FLYING HORSE NORTH FILING NO. 4

FLYING HORSE NORTH FILING NO. 4 PLAT
A PORTION OF THE NE 1/4 SECTION 36, TOWNSHIP 11 SOUTH, RANGE 66 WEST,
A PORTION OF THE SOUTH HALF SECTION 30, A PORTION OF NORTH HALF OF SECTION 31
TOWNSHIP 11 SOUTH, RANGE 65 WEST OF THE SIXTH PRINCIPAL MERIDIAN.

DRAWN BY	JWT
CHECKED BY	ERF
H-SCALE	1" = 100'
JOB NO.	2417-01
DATE CREATED	9/9/24
DATE ISSUED	DRAFT
SHEET NO	2 OF 4

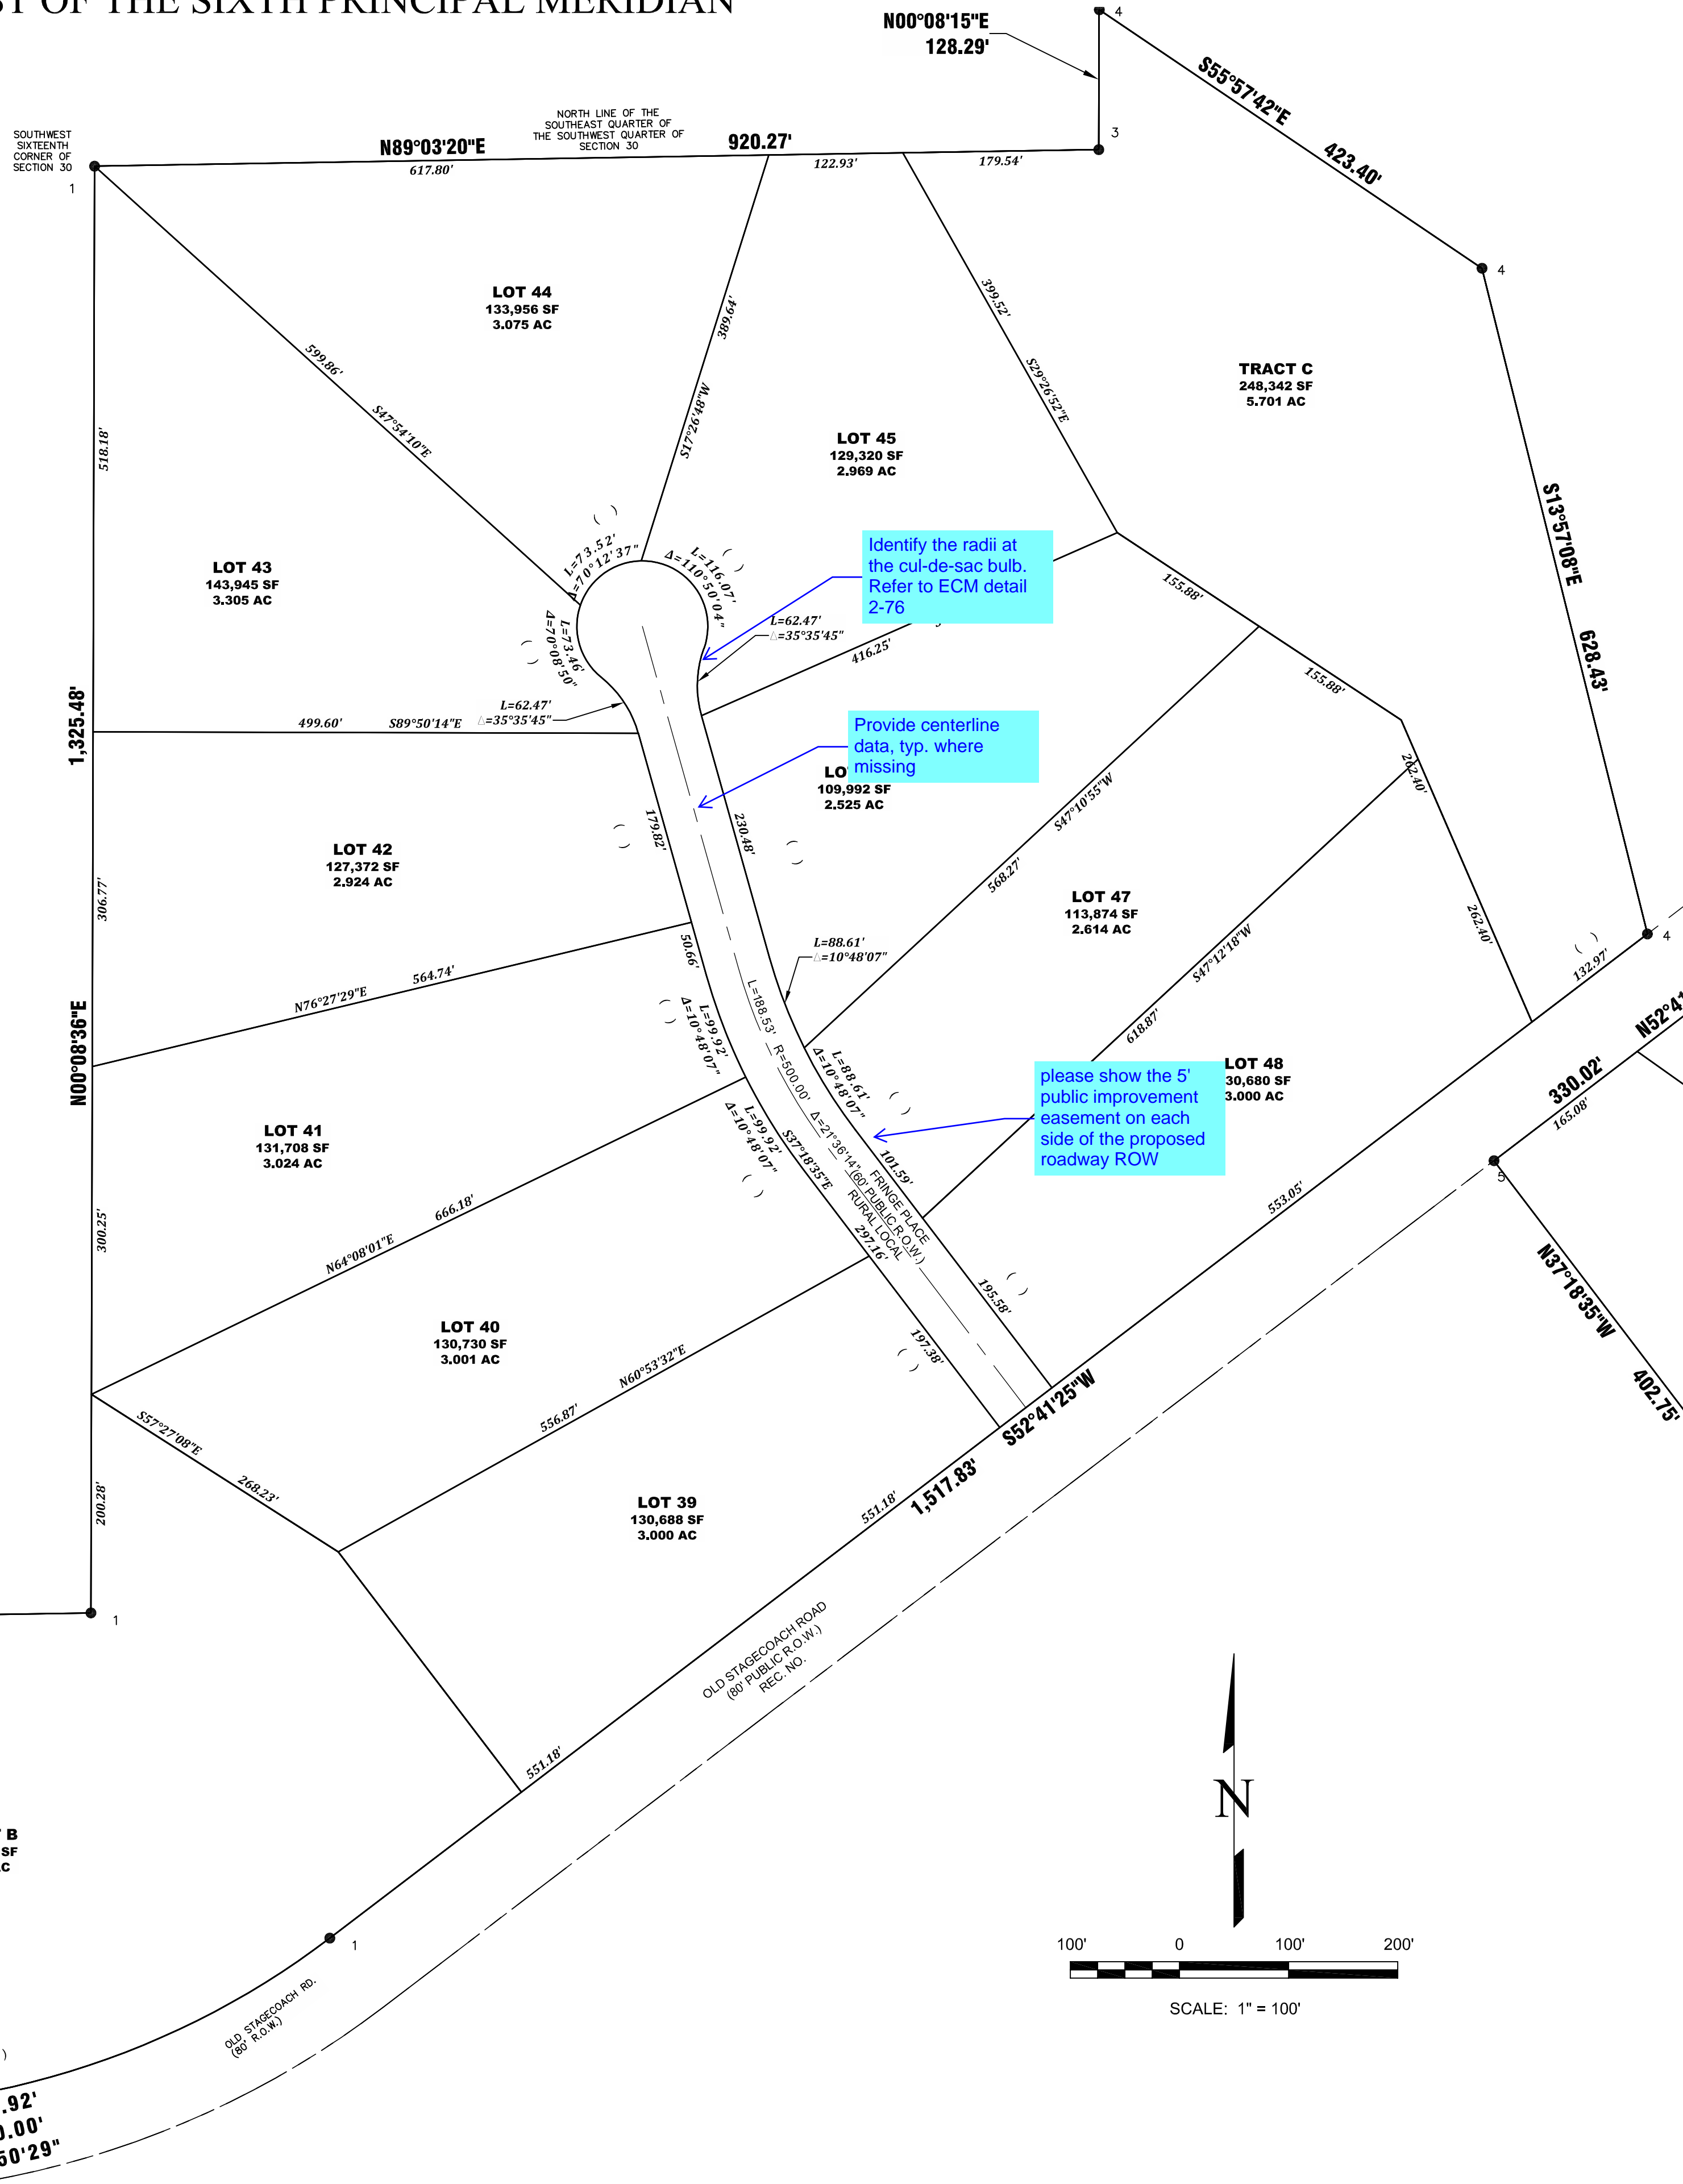
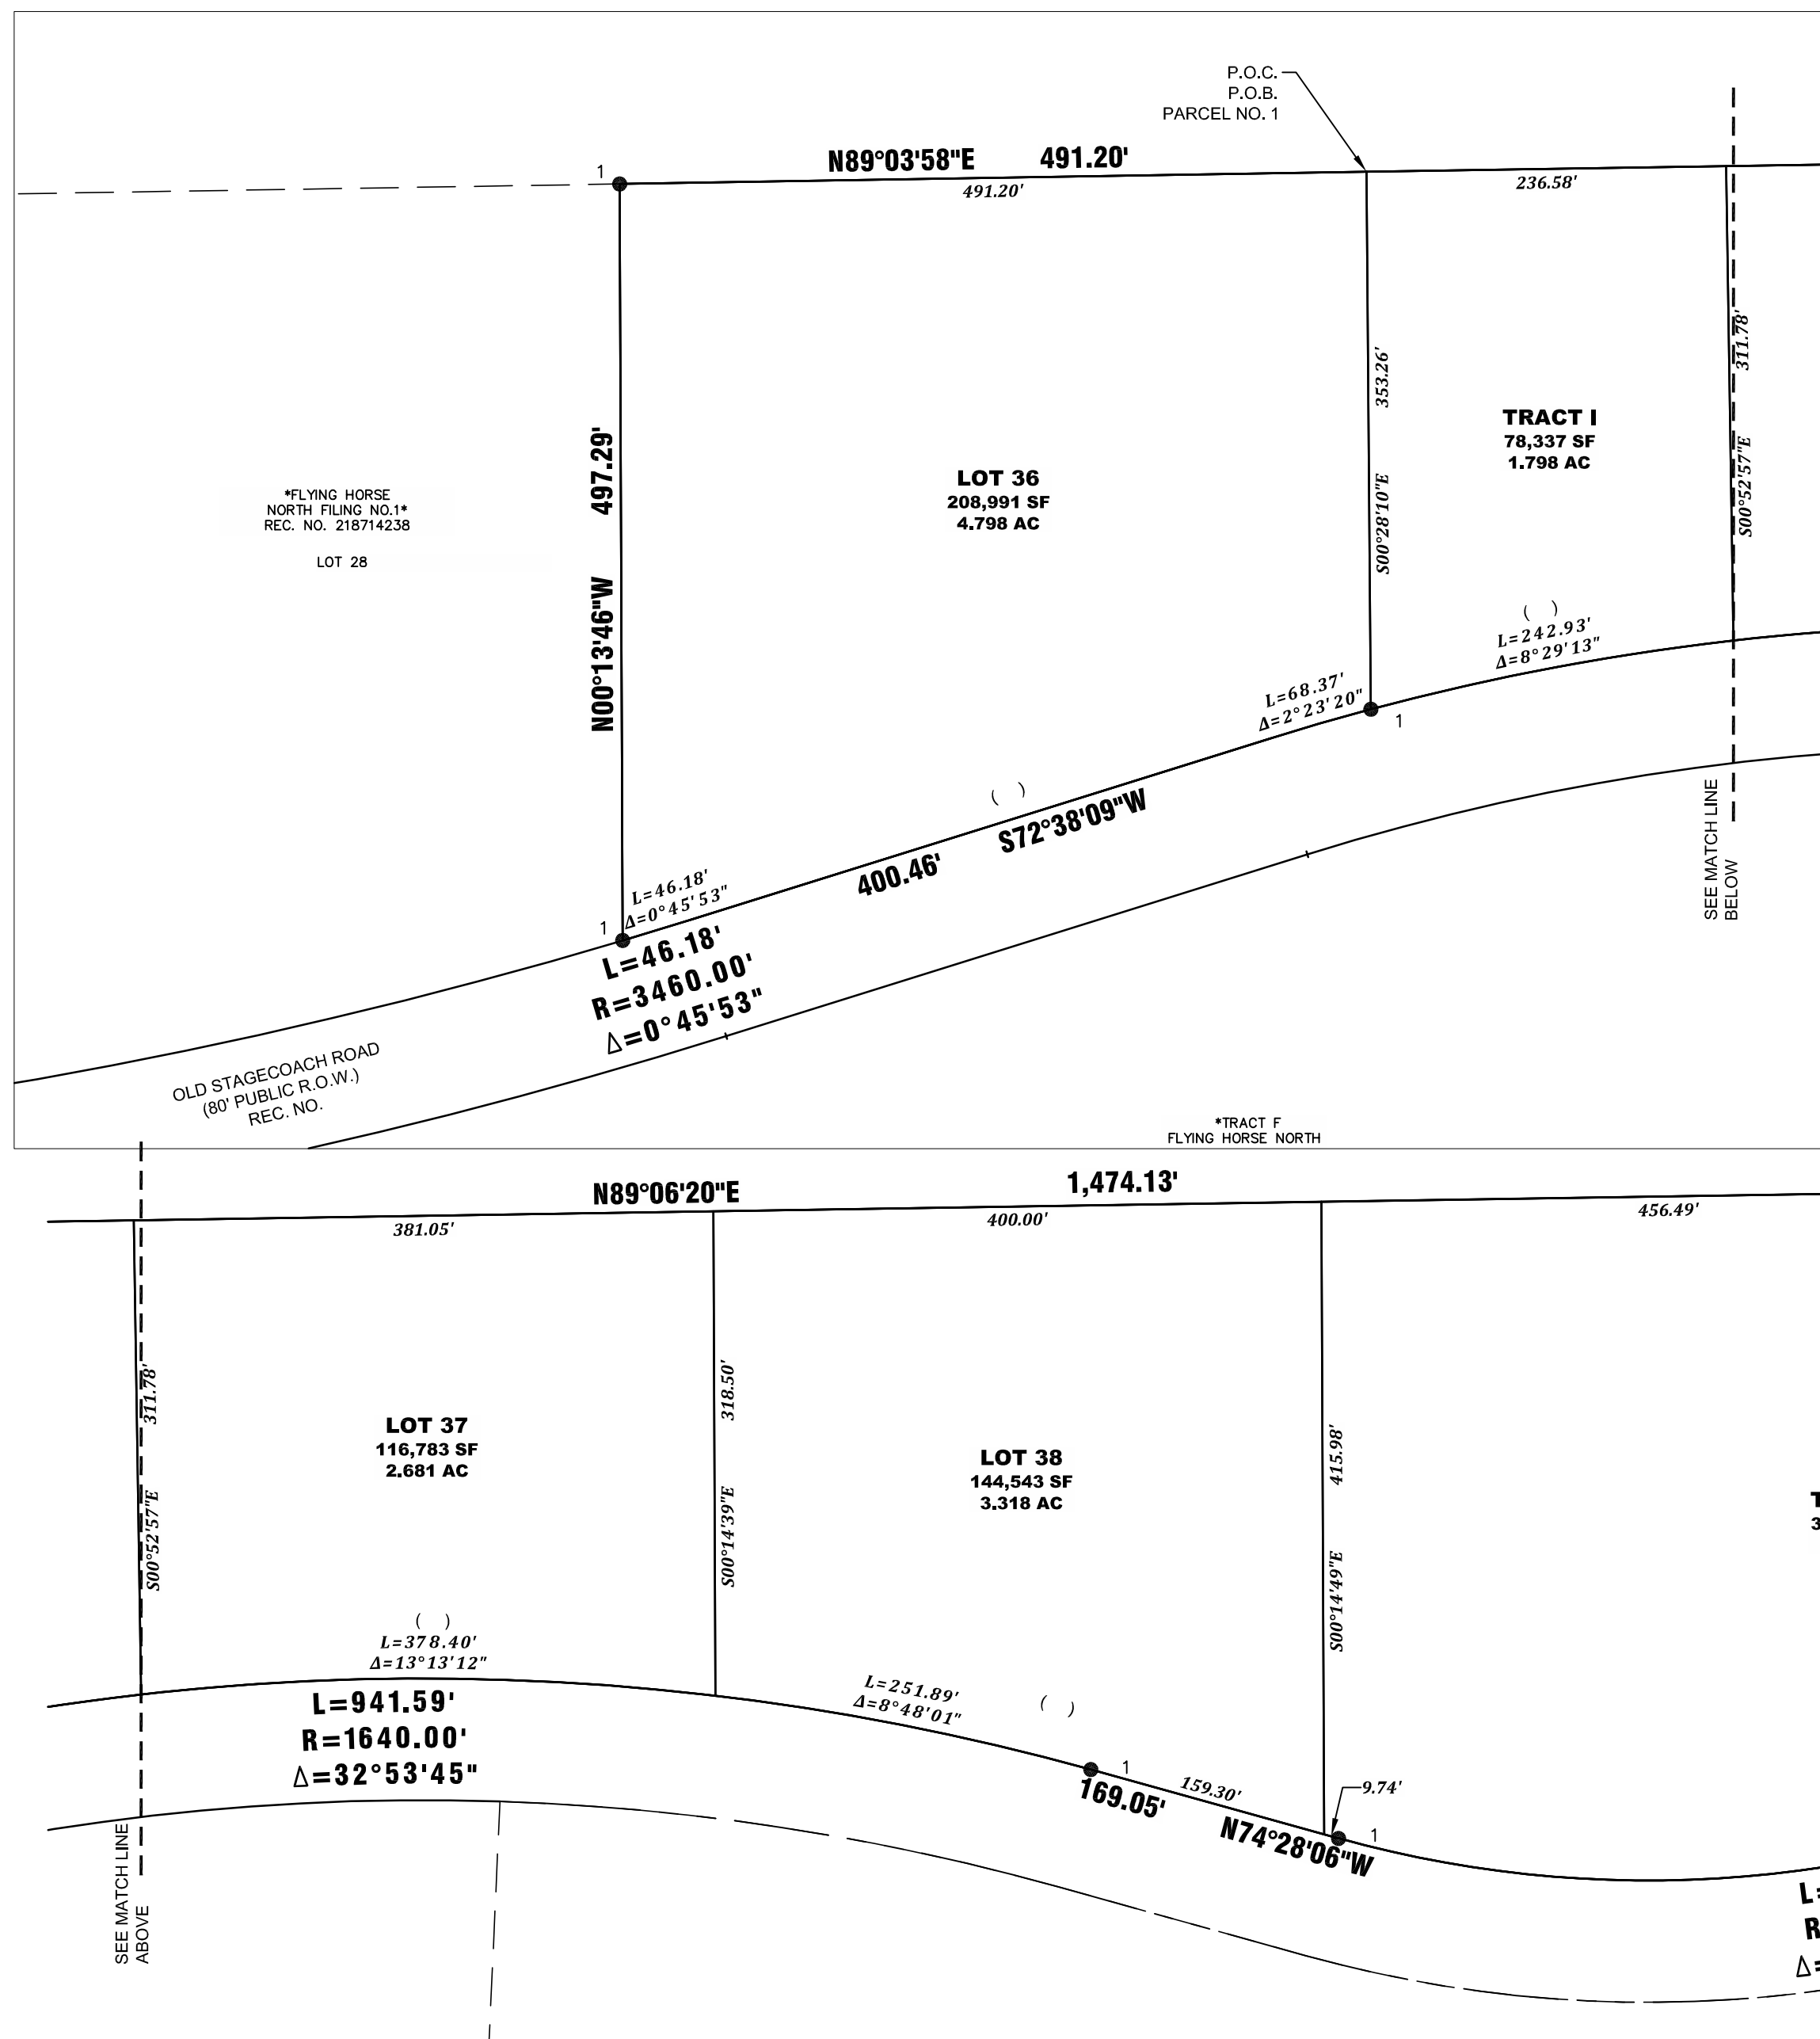
I recommend including a sheet before this one that illustrates the entire filing on one sheet.

Easements depicted on the PUDSP plan are not depicted here. Please depict all proposed and existing easements, and identify any that are proposed to be vacated with the plat.

DRAWN BY	JWT
CHECKED BY	ERF
H-SCALE	1" = 100'
JOB NO.	2417-00
DATE CREATED	9/9/24
DATE ISSUED	DRAFT
SHEET NO	4 OF 4

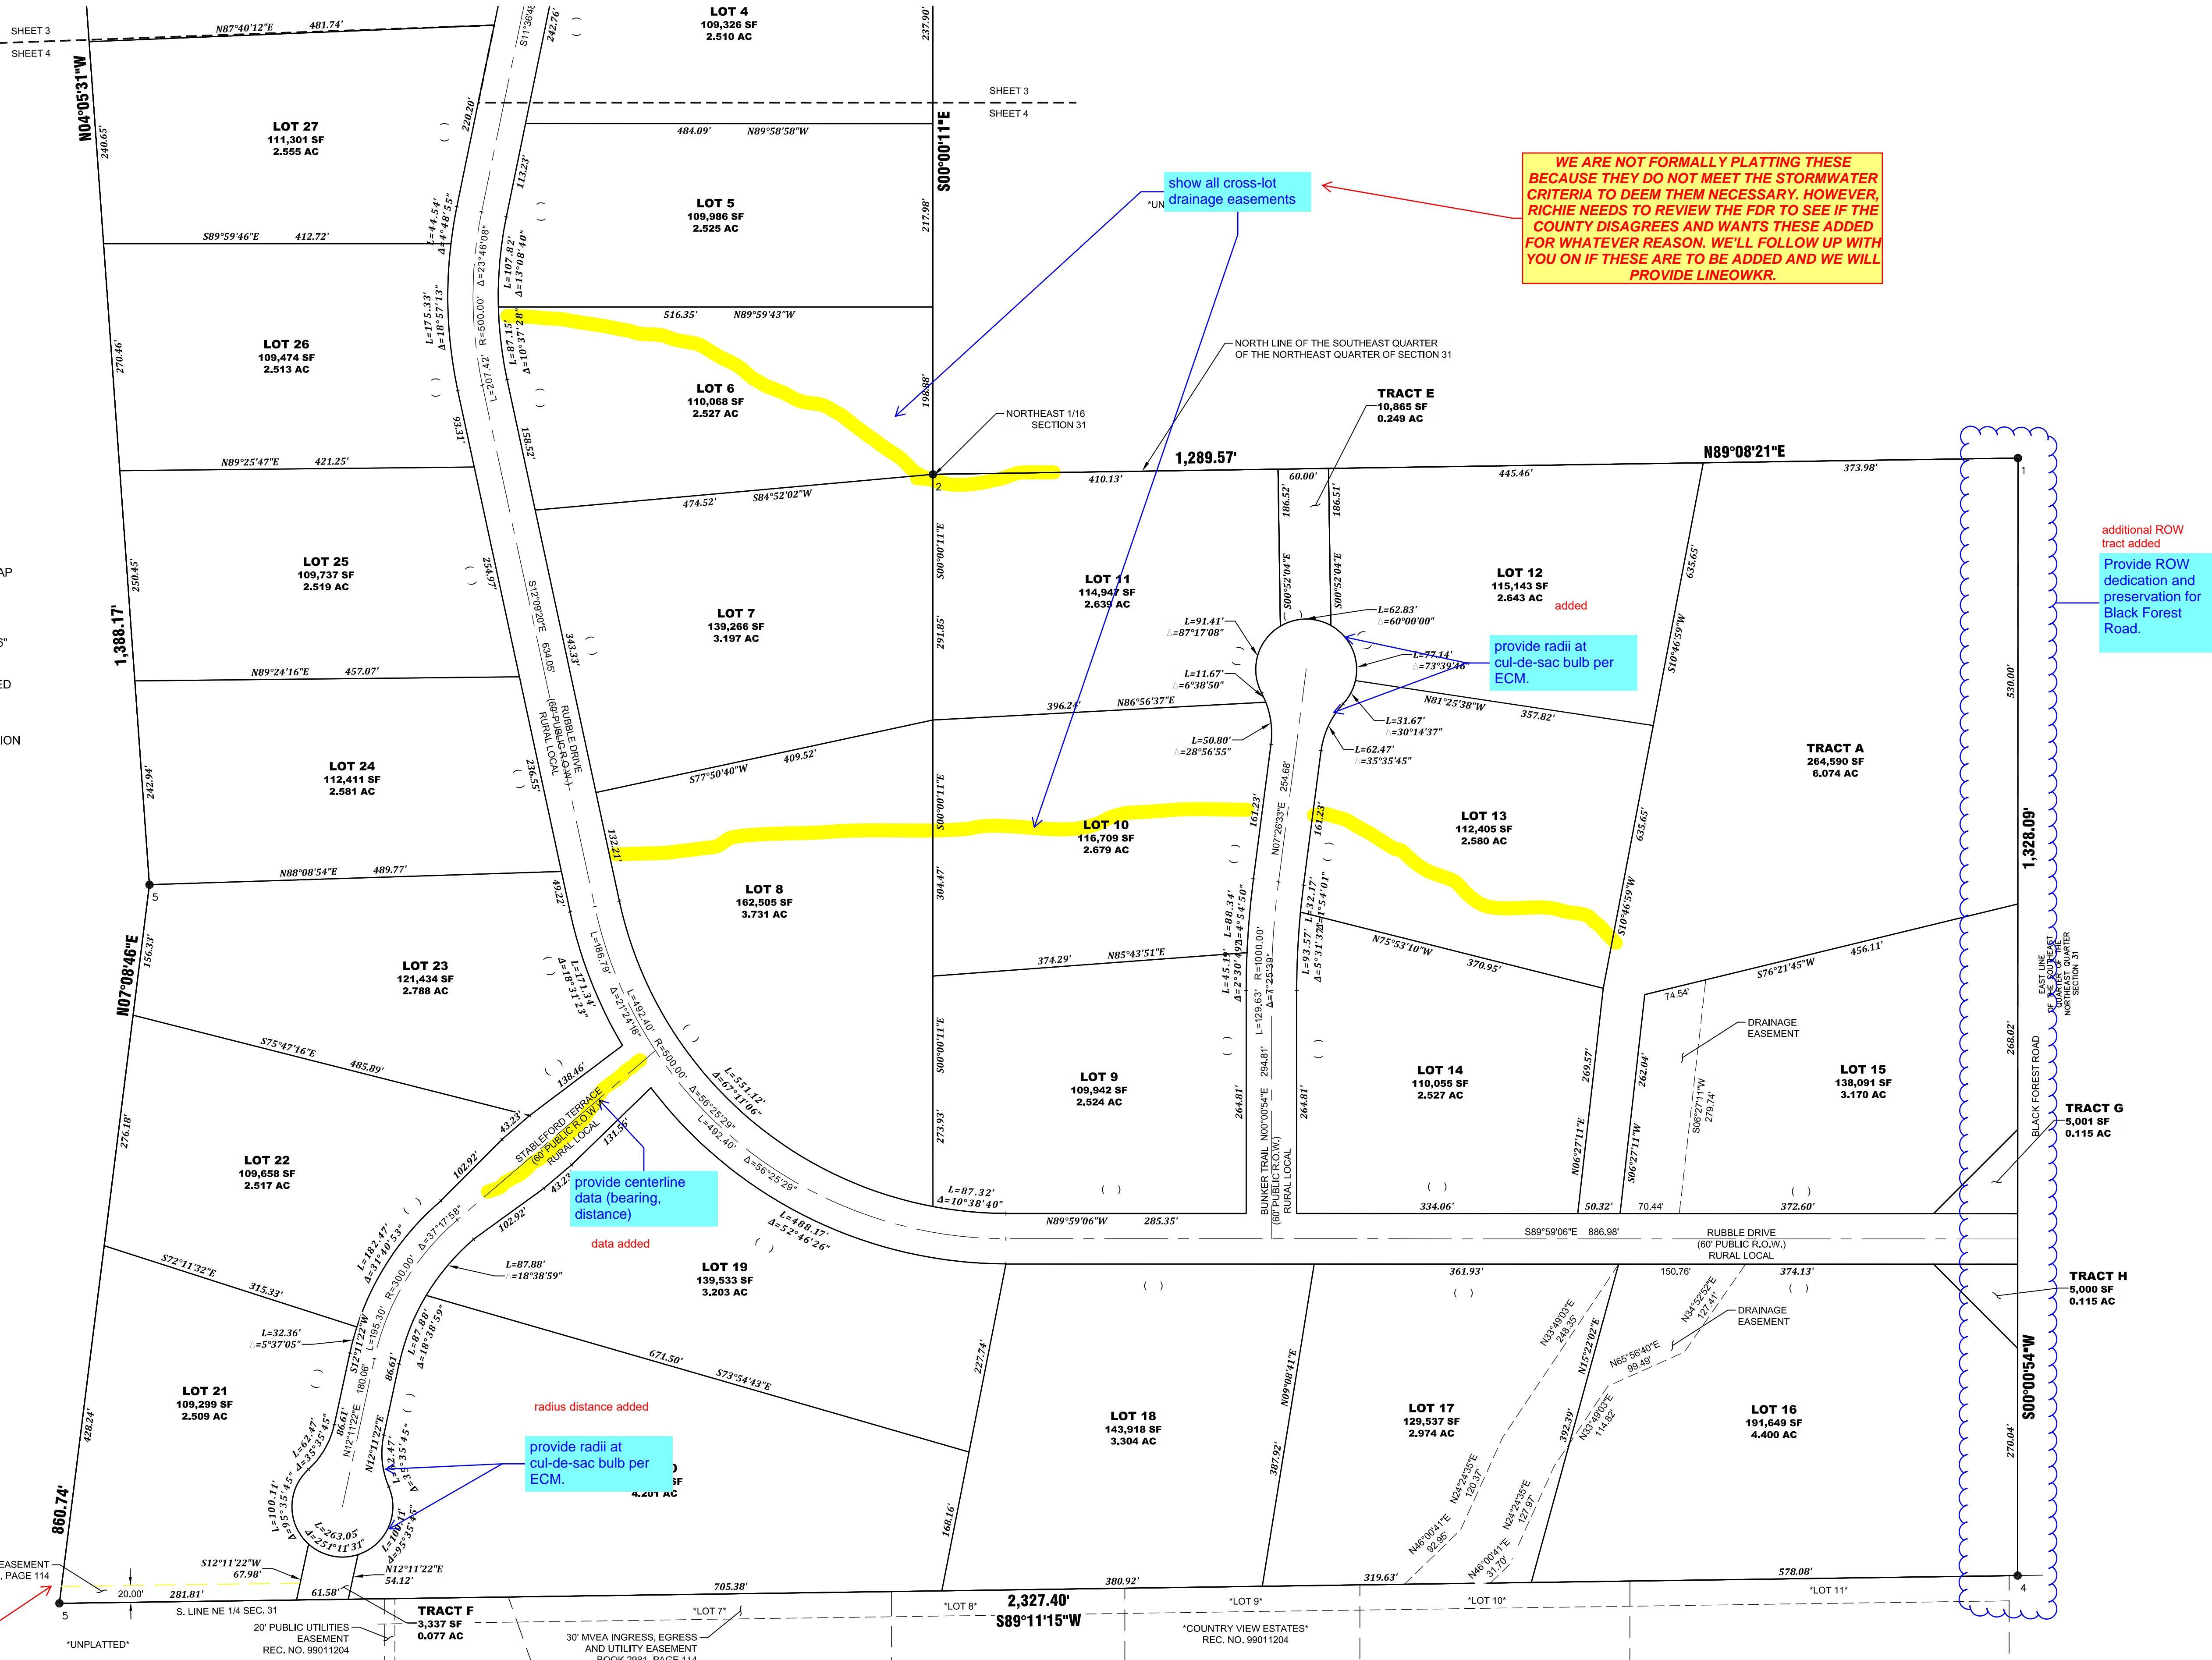
NOW 25'....OR DID
WE GET RID OF
THIS, BLAINE?

WE ARE NOT FORMALLY PLATTING THESE BECAUSE THEY DO NOT MEET THE STORMWATER CRITERIA TO DEEM THEM NECESSARY. HOWEVER, RICHIE NEEDS TO REVIEW THE FDR TO SEE IF THE COUNTY DISAGREES AND WANTS THESE ADDED FOR WHATEVER REASON. WE'LL FOLLOW UP WITH YOU ON IF THESE ARE TO BE ADDED AND WE WILL PROVIDE LINEOWKR.
